Summary of Items Discussed in 3/2023 APSEC Discussion Forum (ADF) on 4 August 2023

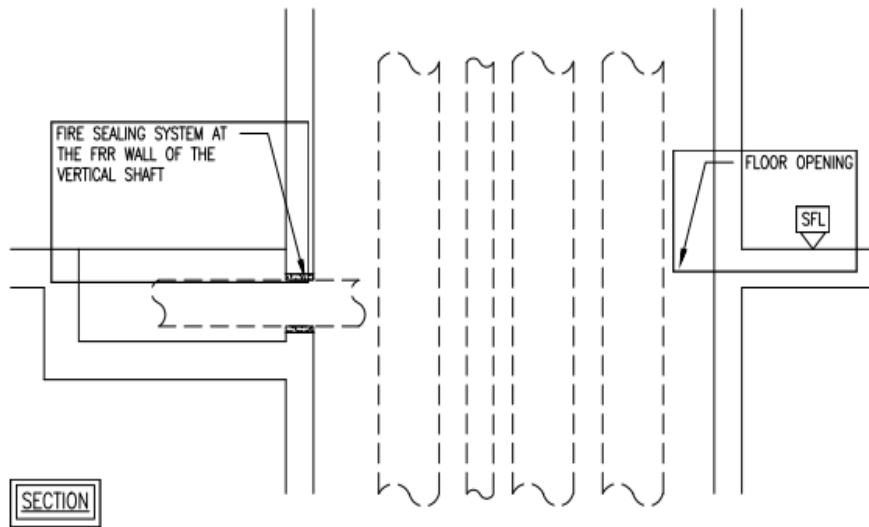
Items proposed by Convenors for Discussion	Summary of Discussion and BD's Response
	Items raised by HKIA	
1.	<p><u>GFA Calculation of Covered Area under Portal above Driveway</u></p> <p>Referring to item 18 of ADF 1/2023 held on 10 February 2023, <i>“the covered area under the portal for metal gate at main entrance of a development might be exempted from GFA calculation on case merits if the size of the portal was commensurate with the scale of the development.”</i> By the same token, if a portal with adequate height and width is provided above an entrance driveway / emergency vehicular access (EVA), could the covered area under the portal be also exempted from GFA calculation?</p>	<p>BD advised that the covered area under the said portal might also be exempted from GFA calculation on case merits if the portal was genuine in design and its size was commensurate with the scale of the development.</p>

GENERAL LAYOUT OF DOMESTIC UNIT

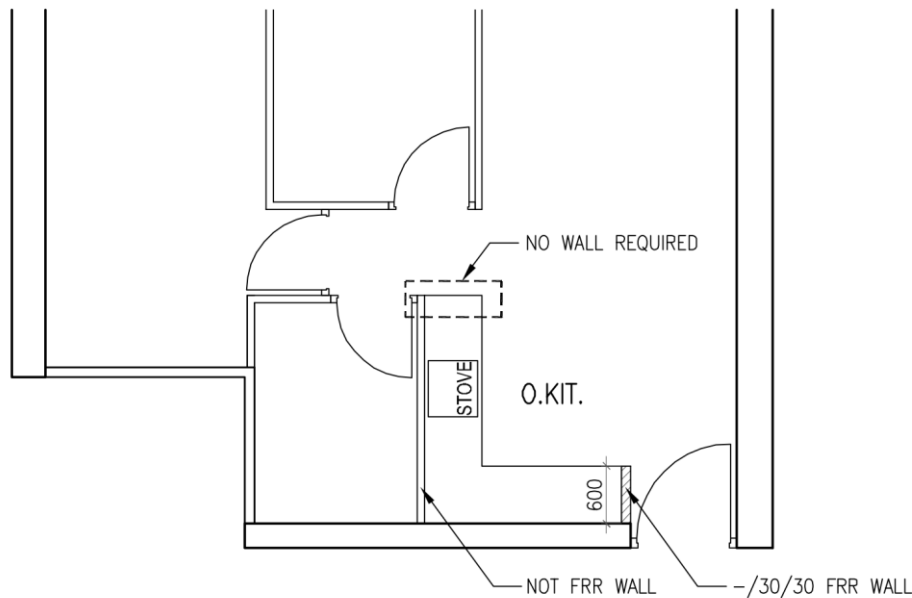
8. **FRR wall at open Kitchen**

Referring to Clause C13.4(d) of the FS Code, it is our understanding that full

height 600 mm wide fire rated wall should be provided adjacent to the flat exit door only. It is not necessary to provide wall or fire rated wall at locations indicated in the sketch below.

Please advise if the above understanding is correct.

BD advised that HKIA's understanding was correct.

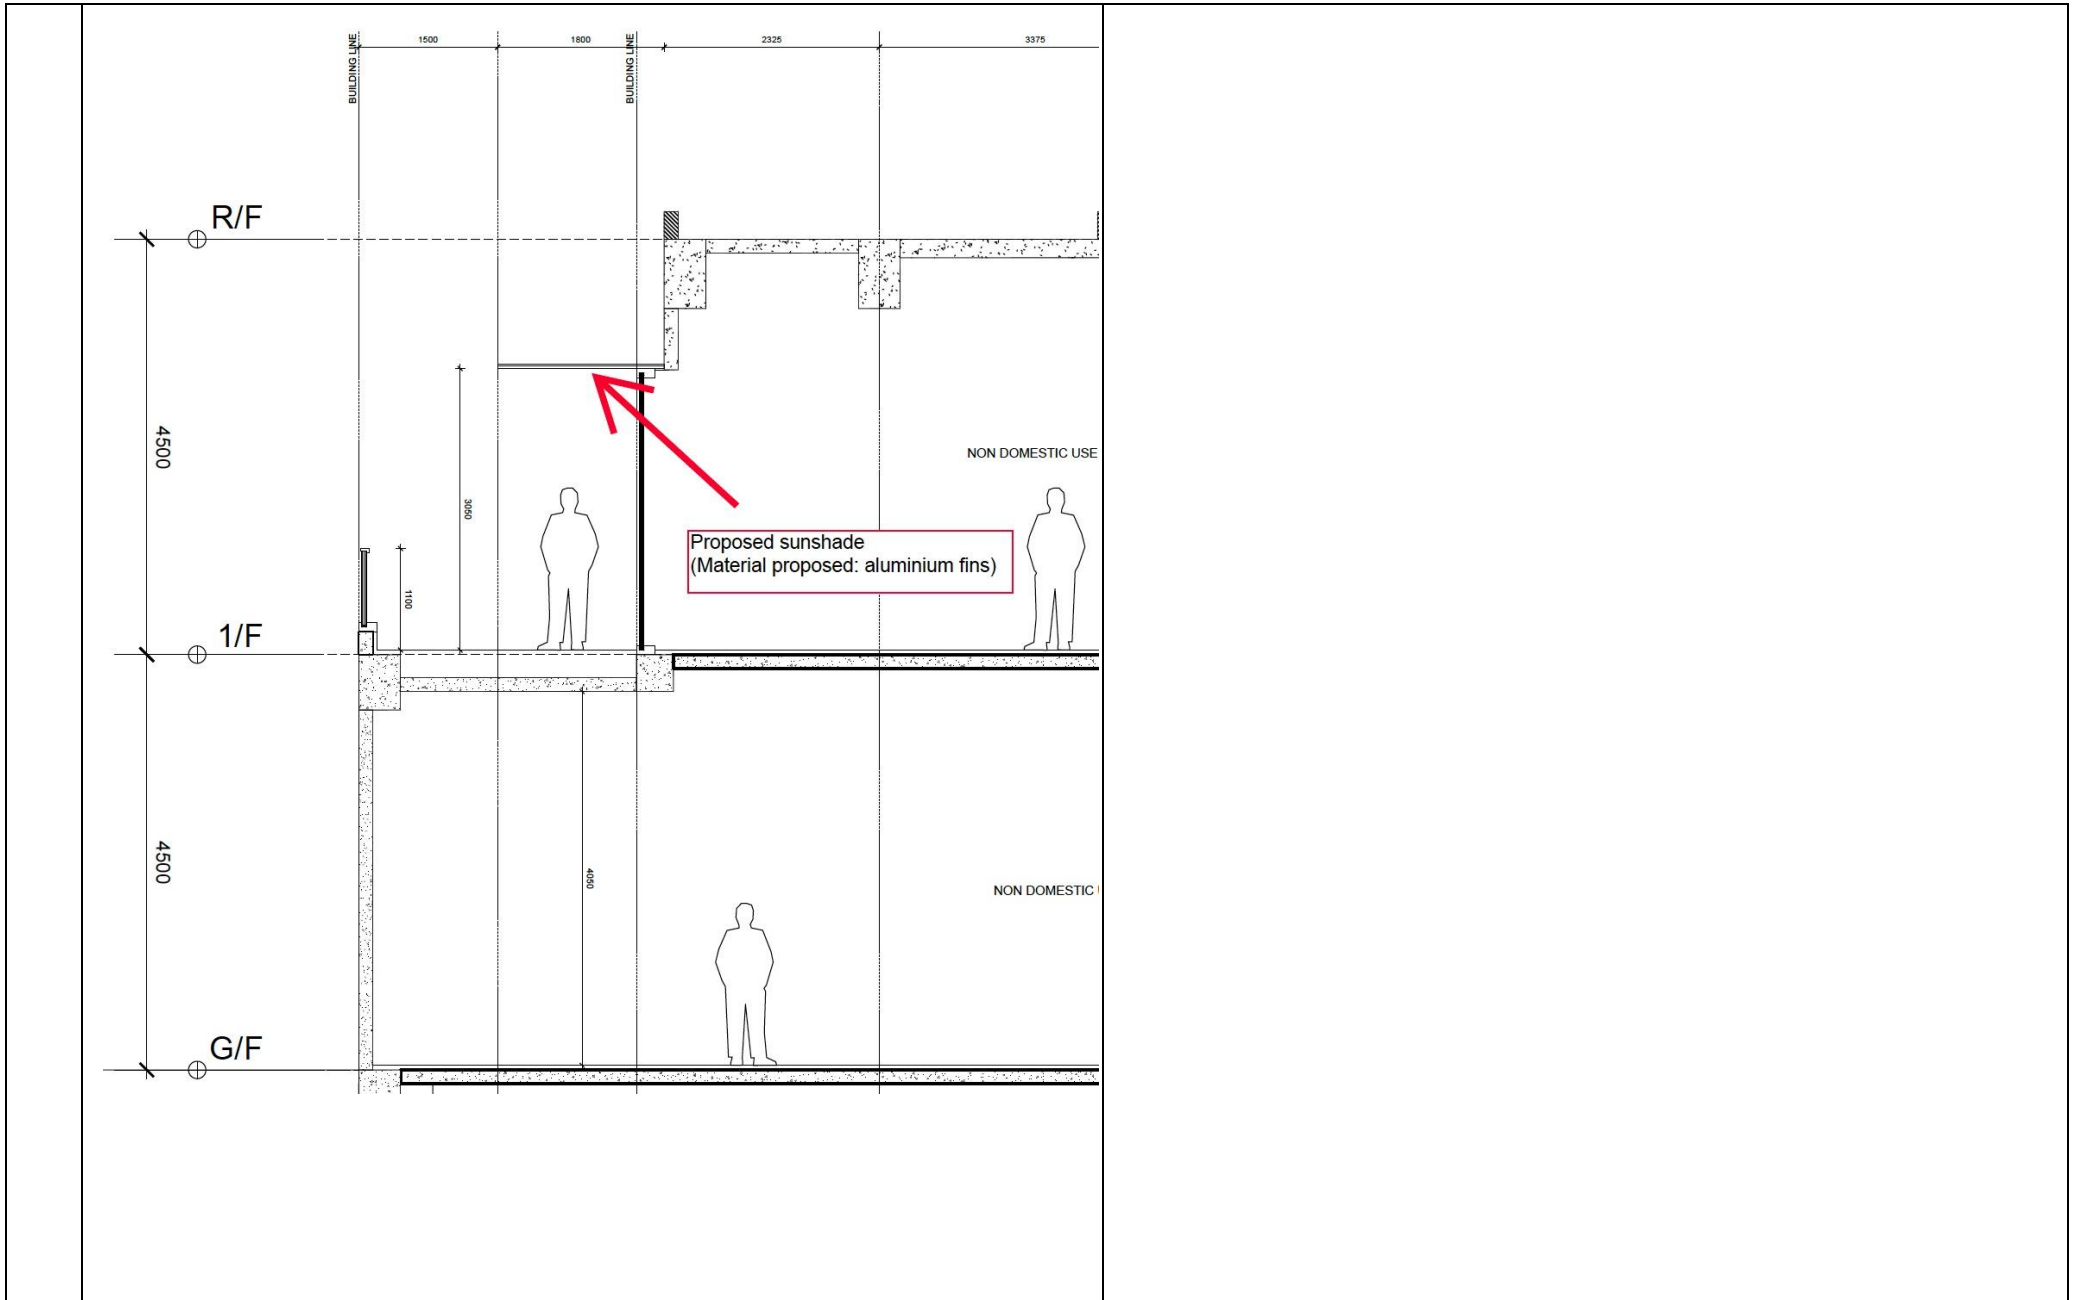
9. **Requirements on Sunshades – PNAP APP-19 and APP-67**

As illustrated in the section below, for sunshades solely used for the purpose of energy conservation projecting over 750 mm from the external wall of a

<p>non-domestic building , besides quantitative assessment on Overall Thermal Transfer Value (OTTV) reduction for meeting the criteria set out in PNAP APP-67 and subject to consideration by the Building Committee, are there any other requirements for the sunshades to be exempted from GFA calculation? There seems no specific requirement set out under PNAP APP-19 & APP-67.</p>	<p>m from the external wall complying with the criteria set out in PNAP APP-67 and APP-156 were not accountable for GFA and site coverage. According to paragraph 10 of PNAP APP-67, in determining whether the sunshades would assist in the reduction of the OTTV, quantitative assessment should be submitted to the Building Authority for consideration, if the sunshades project over 750 mm from the external walls. Similar requirements for sunshades which are conducive to the reduction of RTTV had also been promulgated in PNAP APP-156.</p> <p>In consideration of the design of the proposed sunshade illustrated in the sectional drawing, the sunshade projecting more than 1.5 m from the external wall and over a flat roof should be accountable for GFA under regulation 23(3)(a) of the Building (Planning) Regulations.</p>

BD advised that according to PNAP APP-19, genuine sunshades solely used for the purpose of energy conservation projecting not more than 1.5

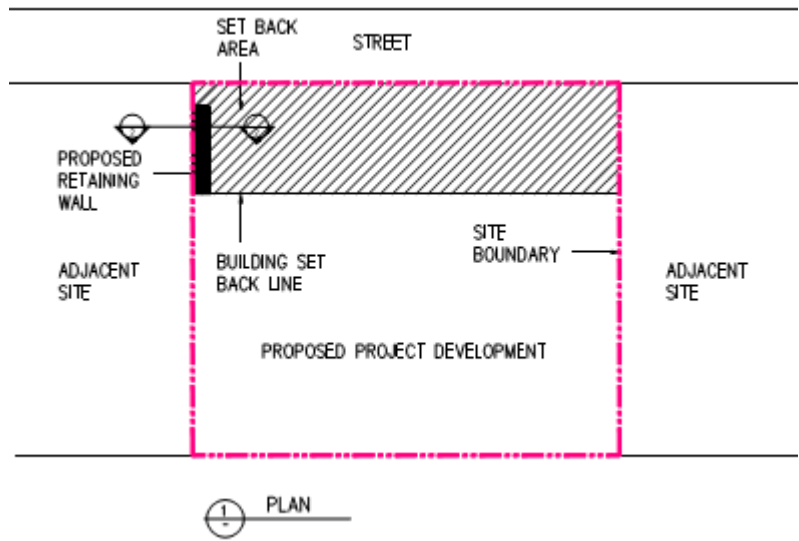
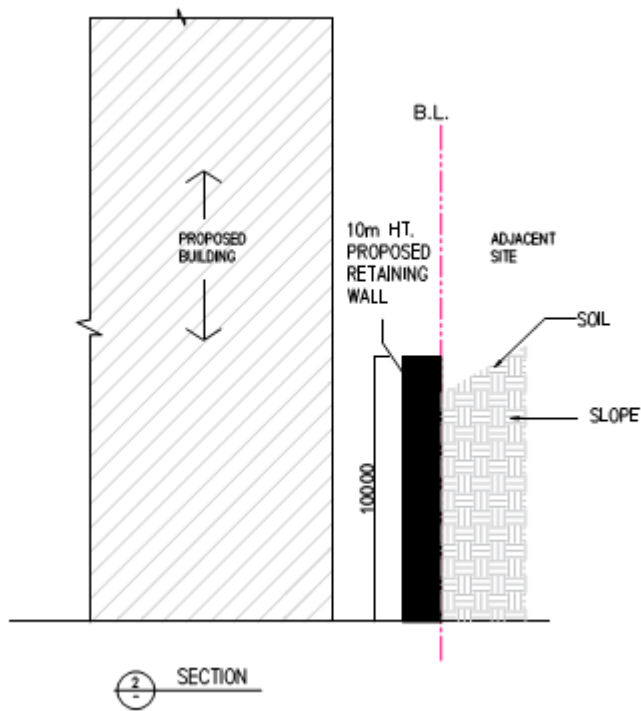
The diagrams below indicated that there is an existing slope in the adjacent site. A proposed retaining wall within the building setback area is required to support the slope for the adjacent site. Please advise if this retaining wall would be allowed to be built within the setback area and not affecting the calculation of the setback area.

In case the retaining wall as illustrated in the diagram was essential in providing support to the adjacent slope, such wall was acceptable to be built within the setback area, provided that criteria laid down in paragraph 3(a) to (f) of the said PNAP were complied with and the area of such wall was excluded from the calculation of the setback area.

Figure 10.10 - Typical profiled steel sheets

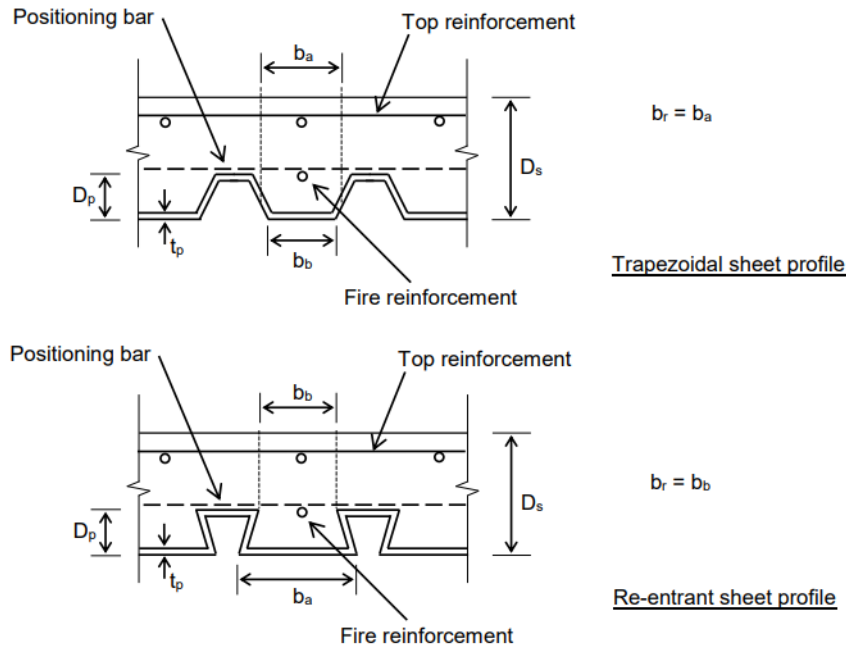
13.	<p><u>Bondek Slab Design</u></p> <p>If the profiled steel sheets are adopted as permanent formwork, the typical details in the Code of Practice for the Structural Use of Steel 2011 (2021 Edition) (Steel Code) and in Bondek catalogue can be referred to such that the position bars / distribution bars are placed on the profile sheet ribs as shown in Figure 10.10 of the said Code extracted below:</p>	<p>BD advised that for the profiled steel sheets which acted as permanent formwork only, the reinforced slab thickness, i.e. $D_s - D_p$, should comply with the requirements of the Code of Practice for Structural Use of Concrete 2013 (2020 Edition) and the FS Code against the specified fire resistance rating.</p> <p>In accordance with Clause 10.4.3 of the Steel Code, nominal minimum slab thickness of concrete given in Table 10.9 and Table 10.10 were applicable to composite slab with profiled steel sheets. Notwithstanding, a full-scale structure fire tests were also required to demonstrate structural adequacy in load carrying capacity, insulation and integrity in fire limit state against specific fire resistance rating.</p>

Also, once the overall slab thickness of the Bondek slab fulfils the minimum thickness required in Table 10.10 of the Steel Code, the slab is deemed to have achieved the respective fire resistance period specified in the said Table, and there is no need to consider the effective slab thickness which is

<p>the thickness of the concrete above the re-entrant profile.</p> <p>Please advise if our understanding is correct.</p>	
<p>AOB Items</p>		
<p>14.</p>	<p><u>Requirements of Building Setback – PNAP APP-132 and APP-152</u> (Item raised by AAP)</p> <p>According to paragraph 3(a) of PNAP APP-132, one of the criteria for considering applications on the ground of setting back a building for its full height from a site boundary abutting on a street is that <i>“the setback of the building is of an area not less than 8% of the site area for non-domestic buildings and not less than 18% of the site area for domestic buildings. For a composite building, the non-domestic and domestic portions of the building should illustrate the required setback of 8% and 18% respectively”</i>.</p>	<p>BD advised that there was no requirement on minimum setback distance under PNAP APP-132 or under the alternative approach for building setback stipulated in Appendix E to PNAP APP-152 except for those stipulated in paragraph 7 of PNAP APP-152.</p> <p>The proposed setback areas illustrated in the diagrams should comply with the required full height and full frontage setback of the building with a total area not less than those stipulated in the said PNAPs and such setback area should contribute to the improvement of the street environment.</p>

Diagram 1

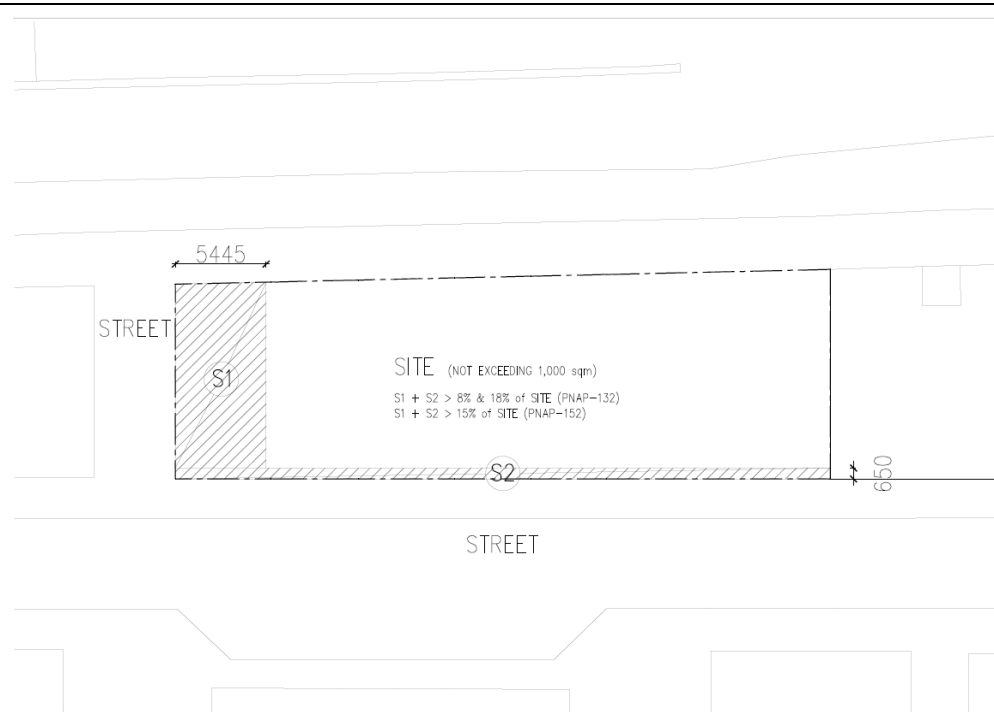
In the above diagram 1, the requirements stipulated in paragraph 3(a) of PNAP APP-132 on set back approach have been complied with as the total setback areas of S1 on the left-hand side and S2 on the front side exceed 18% of the site area of the domestic portion.

Diagram 2

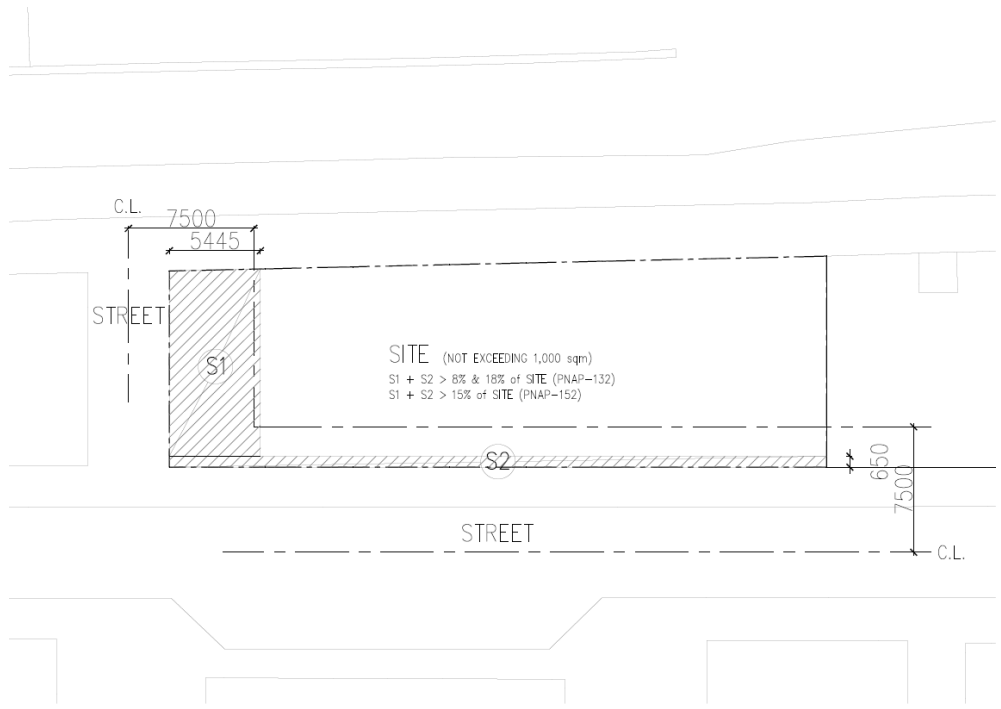
In the above diagram 2, the required building setback of 7.5 m on the two sides of the building from the centreline of the 2 streets as required in paragraph 7(a) of PNAP APP-152, constitute total areas greater than 15% of the site area. In this regard, the requirements for building setback under

<p>PNAP APP-152 have also been complied with, as the total setback areas of S1 on the left-hand side and S2 on the front side exceed 15% of the site area (provided that paragraph 10(b) of Appendix E to PNAP APP-152 has been complied with).</p> <p>We observed that some BD officers do NOT require <u>minimum</u> distance of building setback facing each of the streets. However some BD officers require and impose a minimum <u>1 m</u> setback distance. What is the policy of BD when there is in fact <u>NO other requirements on minimum setback distance</u> apart from those stipulated in PNAP APP-132 and APP-152 above?</p>
